**JOINT REGIONAL PLANNING PANEL**  
**(Sydney East Region)**  
**SUPPLEMENTARY REPORT**

JRPP No	2015SYE170
DA Number	15/216
Local Government Area	City of Botany Bay
Proposed Development	Integrated Development Application for the construction of a mixed use development incorporating 229 units across a 4 storey residential podium (including 3 levels of sleeved parking) and 3 x 10 storey residential towers above, 2 levels of basement and at grade parking for 391 cars, a 58sqm retail tenancy; strata subdivision; the construction of the northern half of a new east-west street (with pocket park to Kent Road) and dedication to Council; a north-south oriented private park (with public right-of-way); stratum subdivision; excavation, earthworks and landscaping.
Street Address	1-5 Kent Road, Mascot NSW 2020
Applicant	Karimbla Constructions Services (NSW) Pty Ltd
No. of Submissions	Round 1 – 1 Round 2 – Nil
Regional Development Criteria	Development with a CIV of \$70,788,287
List of All Relevant s79C(1)(a) Matters	<ul style="list-style-type: none"> <li>• Environmental Planning &amp; Assessment Act 1979, Part 4 – Development Assessment &amp; Schedule 4A – Development for which regional panels

**Figure 2:** Privacy treatments to the eastern façade of Building A (Levels 9 – 12)

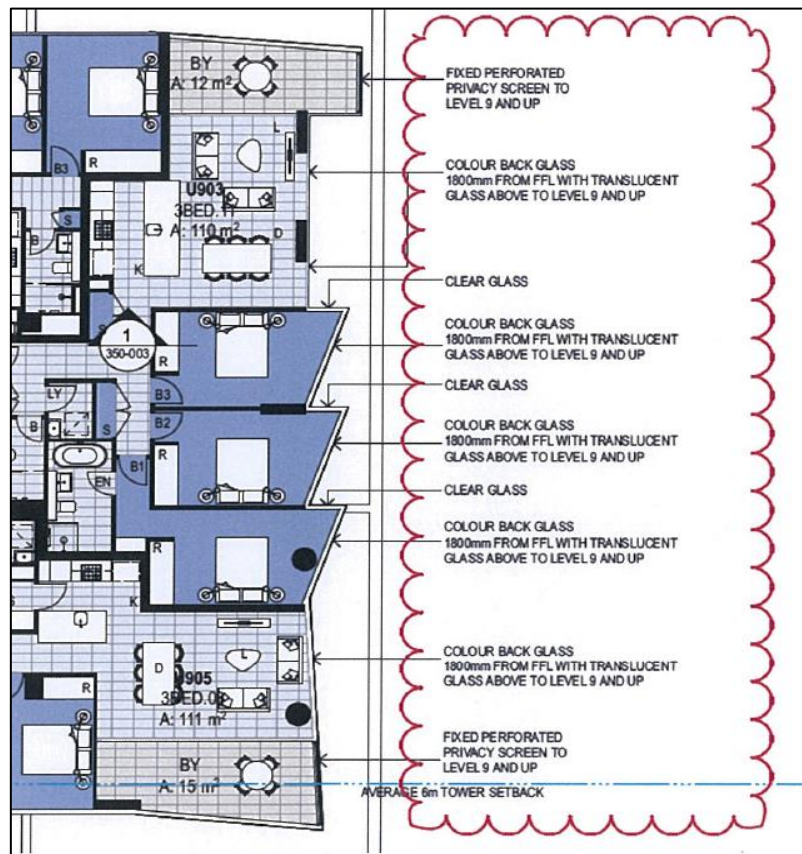
JRPP Required Amendment: *Ensure that the architectural treatment on the eastern façade of Building A and the western façade of Building B complies with the requirements of the Apartment Design Guide where the separation distances are not fully satisfied (i.e. provide alternative mitigating measures).*

Council Comment: The amended architectural drawings indicate the following amendments to Building A (refer to **Figure 2**):

- Full height, fixed perforated privacy screen on the eastern façade of the balconies to Units '03' and '05' from Levels 9 – 12;
- Modified eastern elevation to provide a sawtooth edge design applied to Levels 9 and above (as well as Level 4 – 8 for constructability and visual consistency);
- Modified eastern elevation to provide a snorkel window (clear glass facing north) to the eastern facing bedrooms from Levels 9 and above (as well as Levels 4 – 9); and
- Colour back glass 1800mm from finished floor level to the eastern façade (bedrooms and living area) of Units '03' and '05' from Levels 9 – 12.

The proposed amendments described above satisfy Amendment No. 3 as required by the JRPP.
